April 30, 2014

RE: 3328 Verdun Avenue

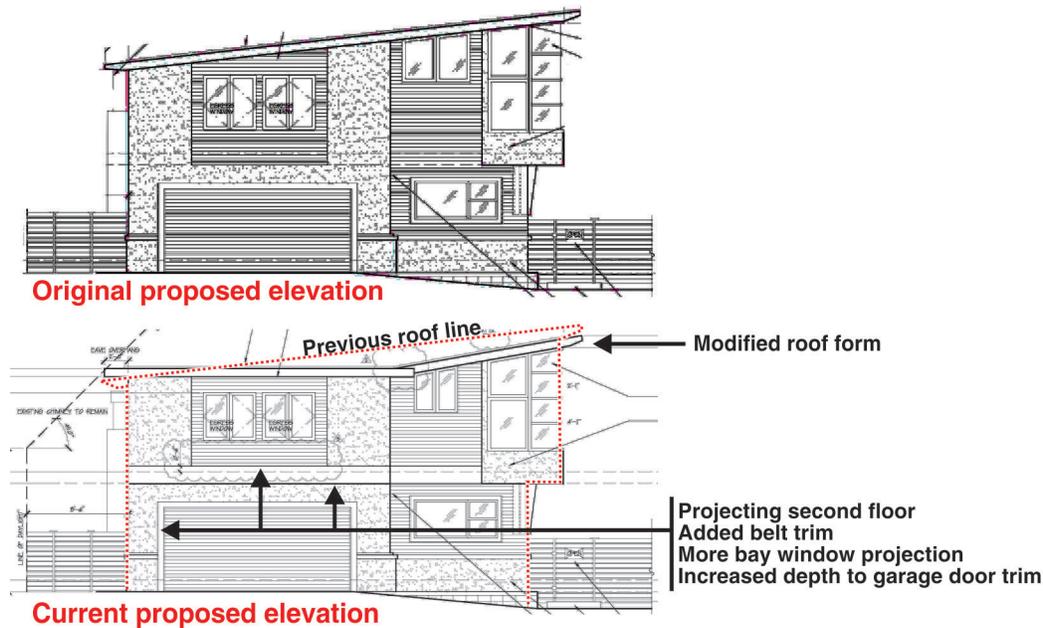
The proposal is to add a partial second floor to the existing house. Placement of the addition would be over the front of the house closest to Verdun Avenue. The home style would change from a gable-fronted Ranch Style home to one that is more modern in appearance with a partial sloped roof at the second floor addition. Bay windows at the new second floor Bedrooms and Family Room are proposed to break up the two-story walls facing the street.

- A modification to the extent of the sloped roof form on the second floor to reduce visual mass seen from the adjacent neighbor, and to better relate to the other nearby homes.
- Breaking up the two-story wall facing Verdun Avenue by the addition of belt trim at the second floor line, a projection of the bedrooms over the first floor facade, and the enhancement of the bay window at the bedrooms;
- Recessing of the garage door to provide greater facade depth.

The applicant has made changes to the design in response to those recommendations. The original and currently proposed front elevations are shown in the diagram below.

While the modified second floor roof form is not exactly the same as recommended, I feel that it is a reasonable solution that I could support. I do not have any other recommendations for changes to the design.
